PARTIAL LEVEL-09 FRAMING PLAN (PHASE-8) (SEQ#47)

SK#23
17 pages
35 Queries
Date: 07-14-2025

PROJECT DESCRIPTION : 1250 MARYLAND AVENUE

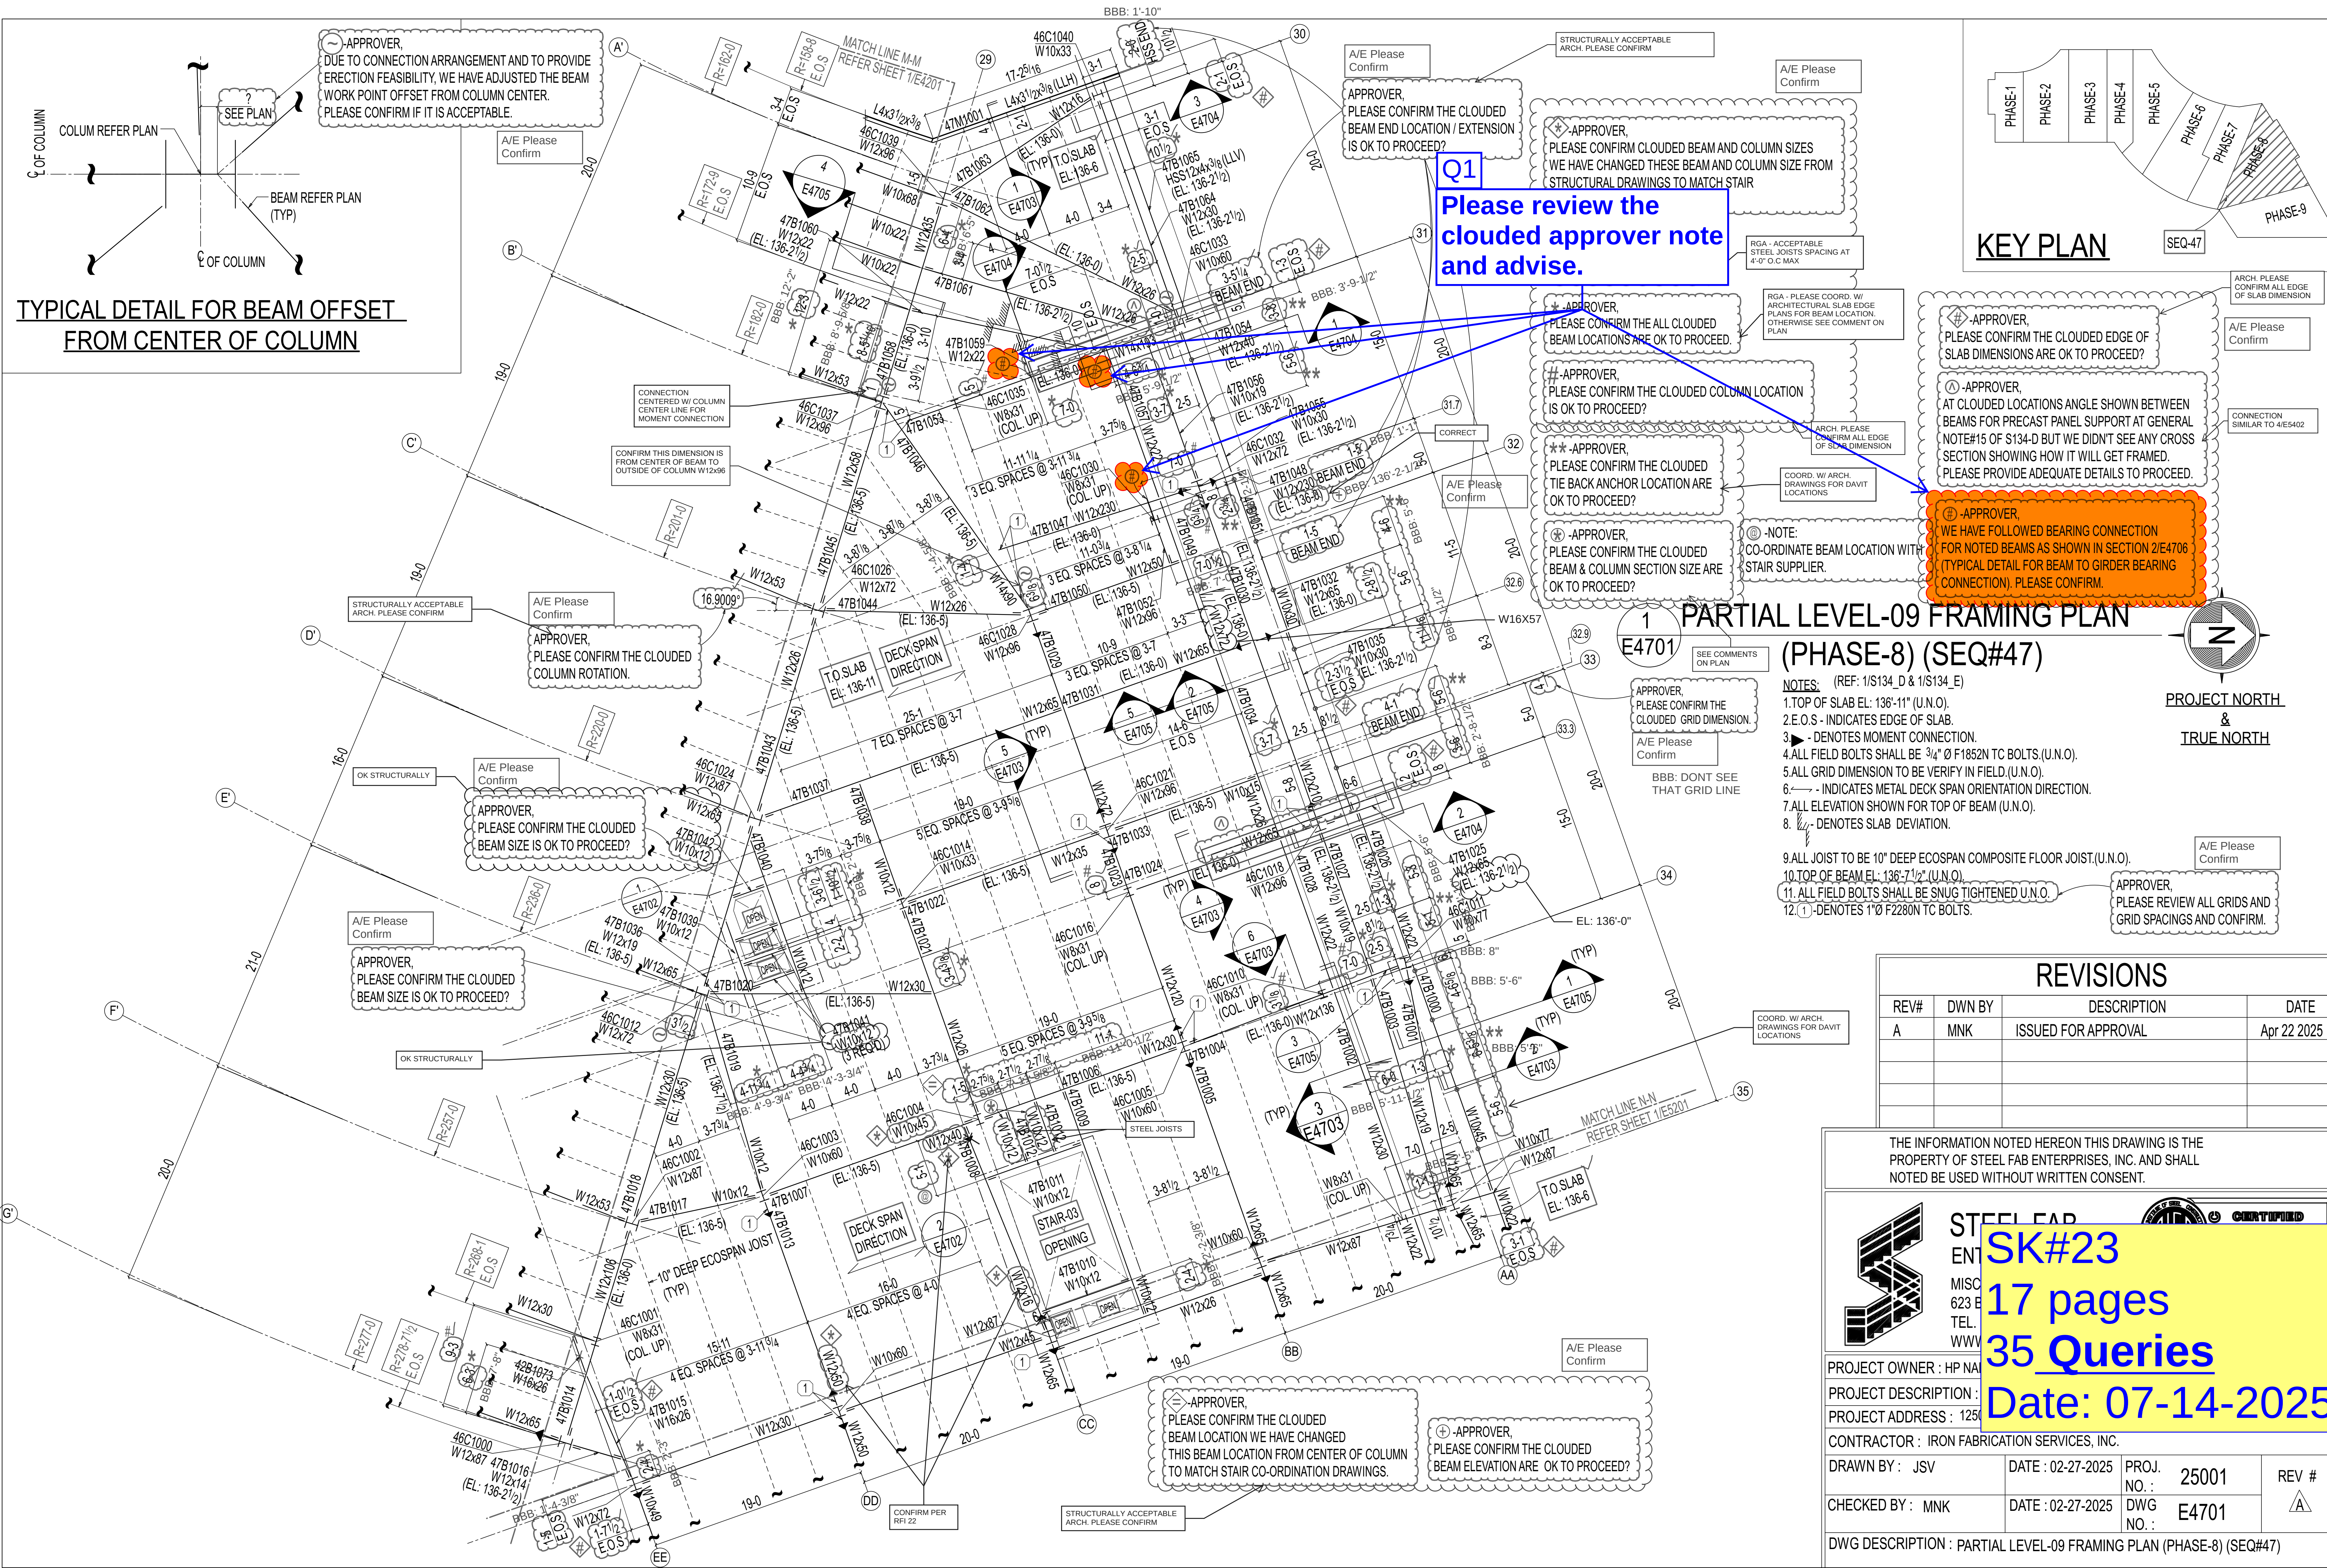
Note: due to software limitations, we are unable to model a beam-to-beam connection directly. Each connection has separate calculations for moment and shear loads. Markups are provided on the drawing – please follow them. Shear tab connection is designed separately for shear load.

PARTIAL LEVEL-11 FRAMING PLAN (PHASE-8) (SEQ#49)

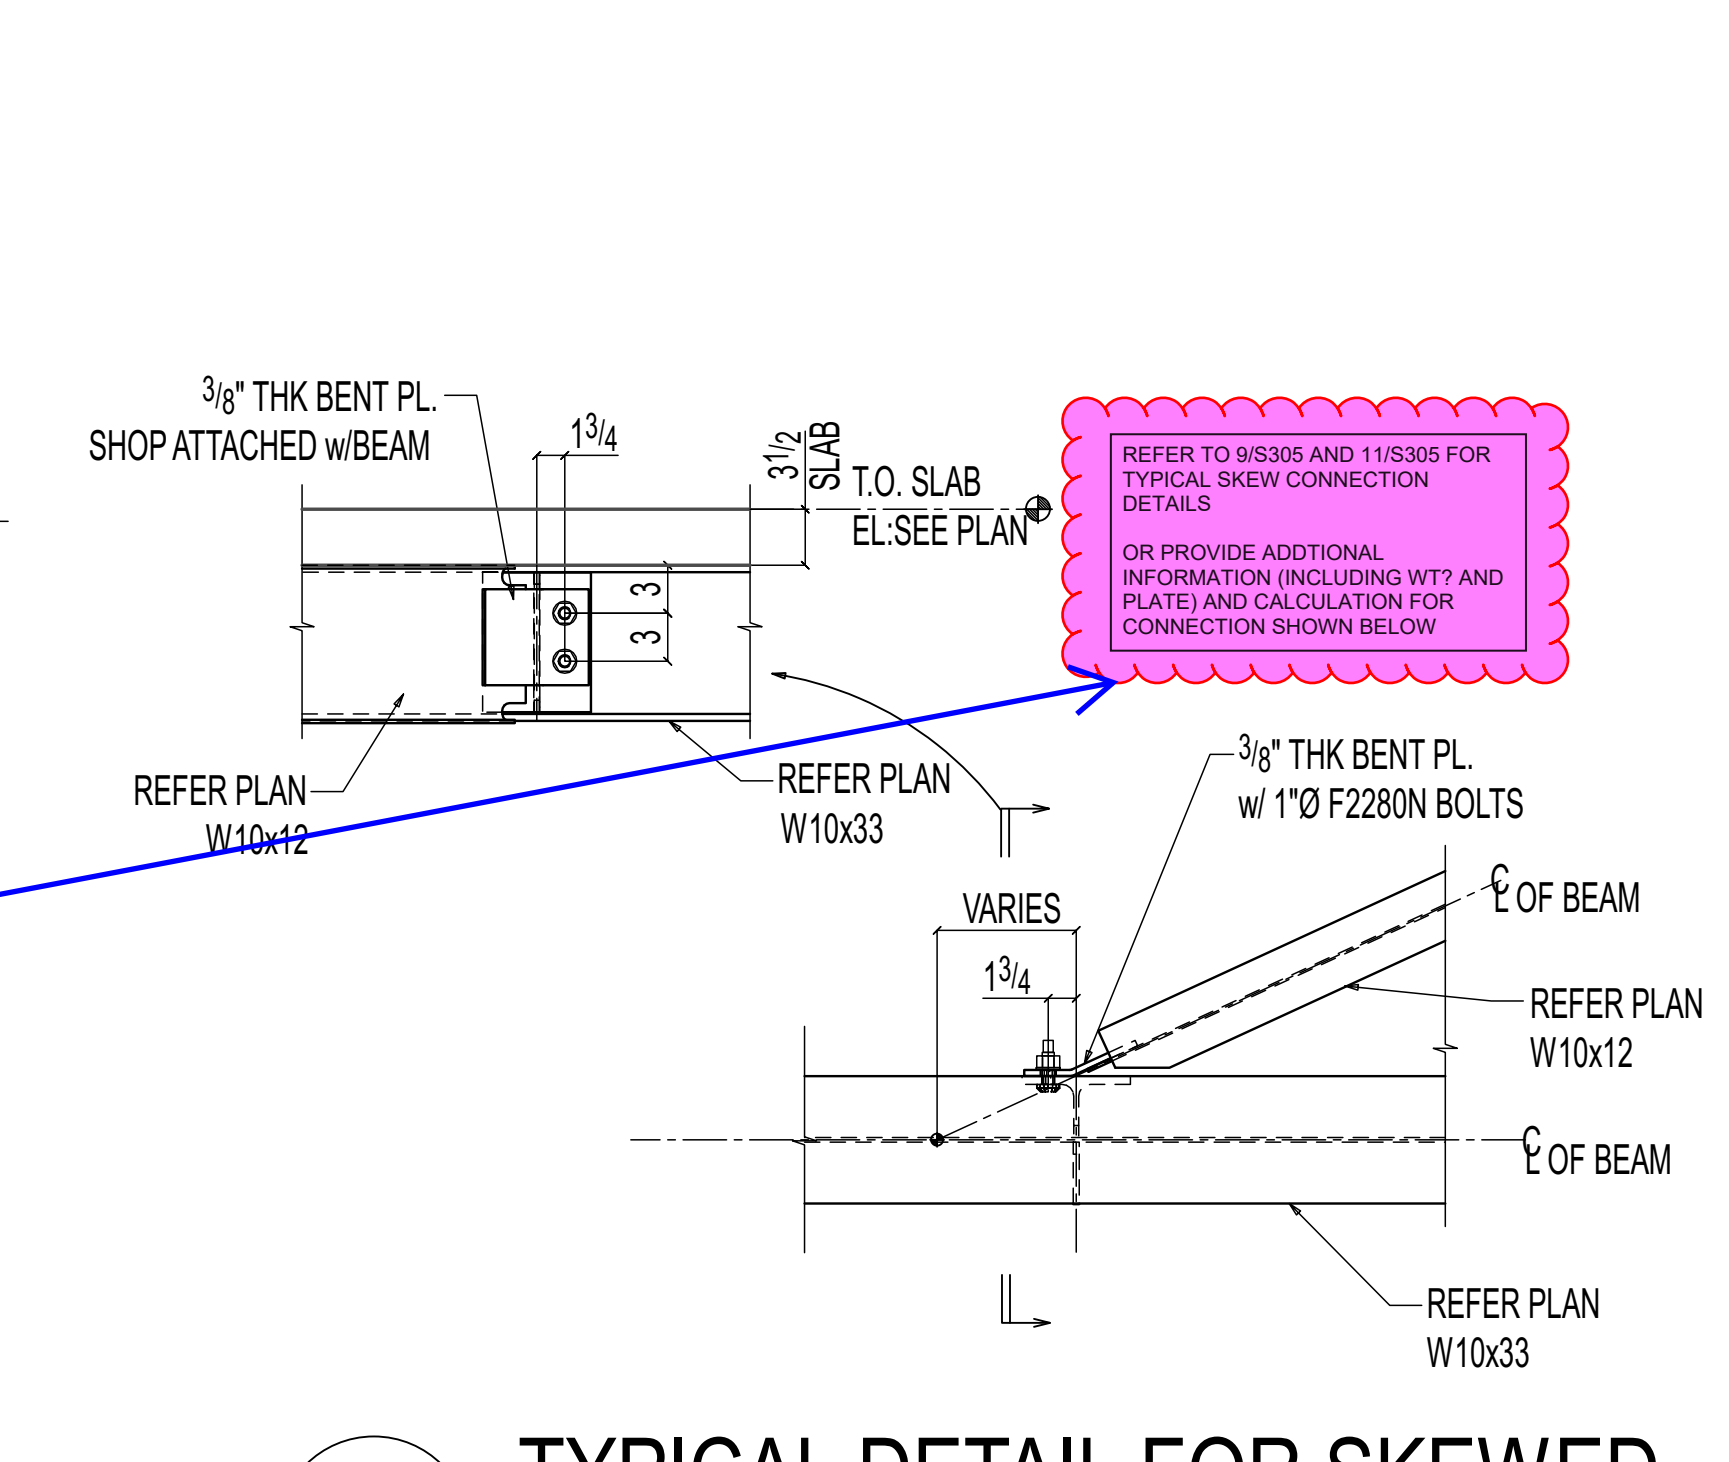
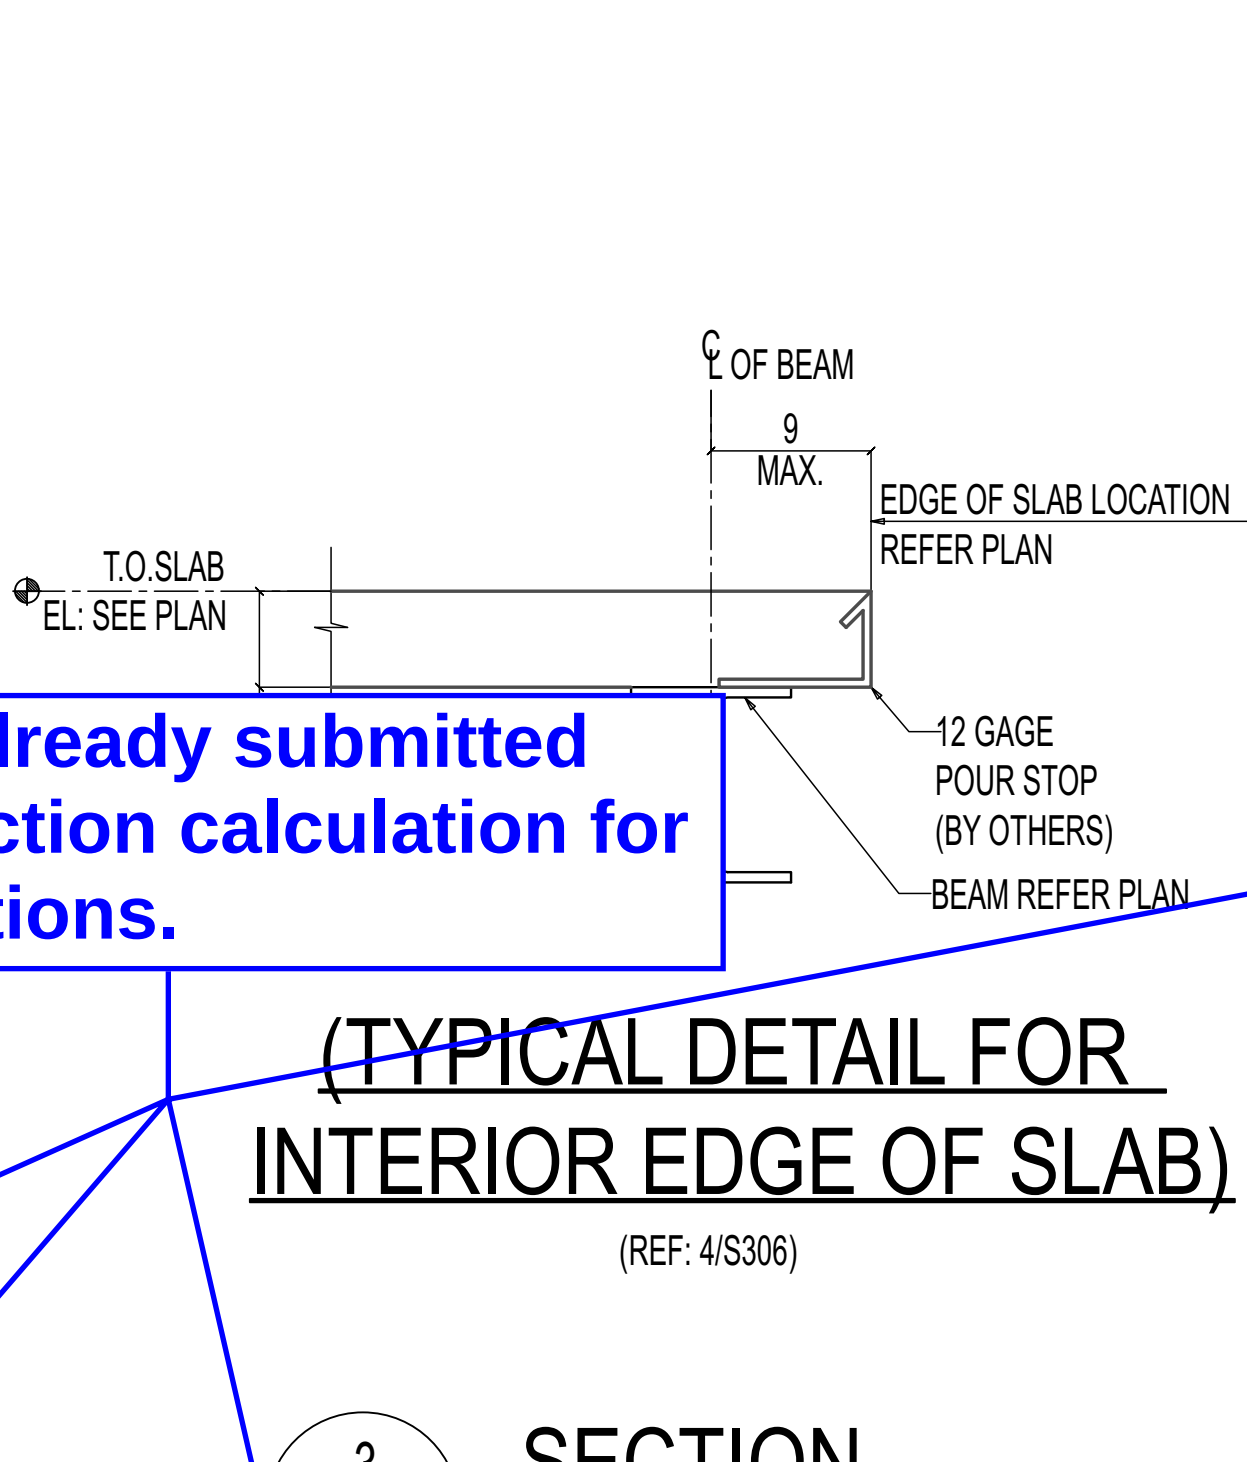
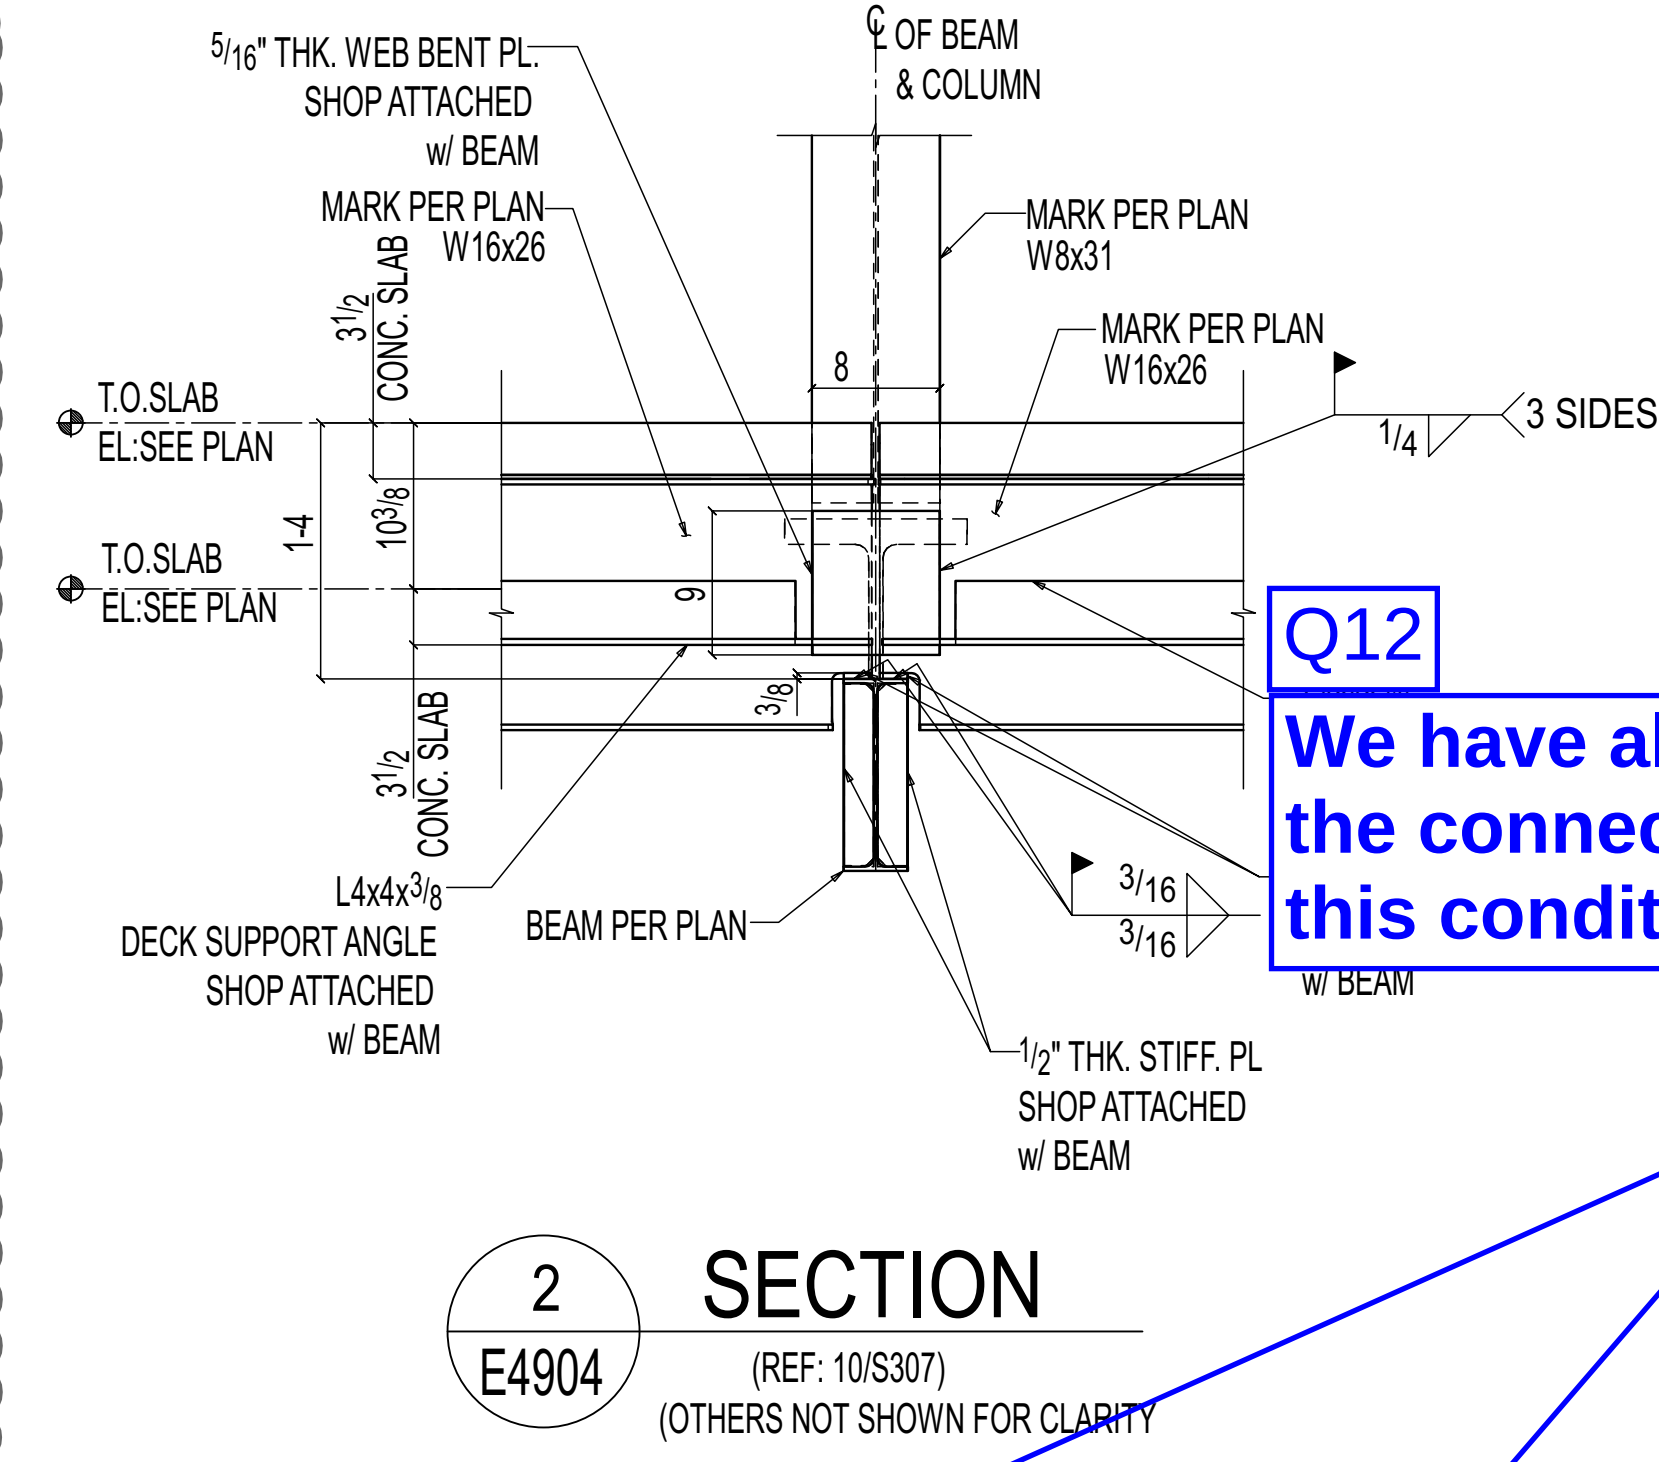
Q10
Please review the green clouded note and confirm the column section size.

APPROVER, PLEASE CONFIRM THE CLOUDED COLUMN SIZE IS OK TO PROCEED?

APPROVER, PLEASE CONFIRM FOR THE CLOUDED BEAM LOCATION WE HAVE REMOVED MOMENT CONNECTIONS AS PER STAIR CO-ORDINATION DRAWING.

APPROVER, WE HAVE FOLLOWED BEARING CONNECTION FOR NOTED BEAMS AS SHOWN IN SECTION 6/E4904 (TYPICAL DETAIL FOR BEAM TO GIRDER BEARING CONNECTION), PLEASE CONFIRM.

Q11
Please review the yellow clouded note and advise.

APPROVER, PLEASE CONFIRM CLOUDED BEAM ELEVATION STRUCTURAL DRAWING S136-E SHOWS EL:158-5 FOR THIS BEAM. BUT WE BELIVE THIS BEAM TOP SHOULD MATCH TOP OF ADJACENT JOIST EL:158-7 1/2. PLEASE CONFIRM.

****APPROVER, DUE TO CONNECTION ARRANGEMENT AND TO PROVIDE ERECTION FEASIBILITY, WE HAVE ADJUSTED THE BEAM WORK POINT OFFSET FROM COLUMN CENTER. PLEASE CONFIRM IF IT IS ACCEPTABLE. (TYP AT SIMILAR CONDITIONS)**

Q12
We have already submitted the connection calculation for this conditions.

APPROVER,
DUE TO THE MOMENT CONNECTION,
WE ARE UNABLE TO SEAT THE JOIST INTO THE BEAM.
THEREFORE, WE HAVE PROVIDED A SEATED ANGLE CONNECTION AS SHOWN.
PLEASE CONFIRM THE SHOWN ARRANGEMENT ARE OK TO PROCEED?
A/E Please Confirm
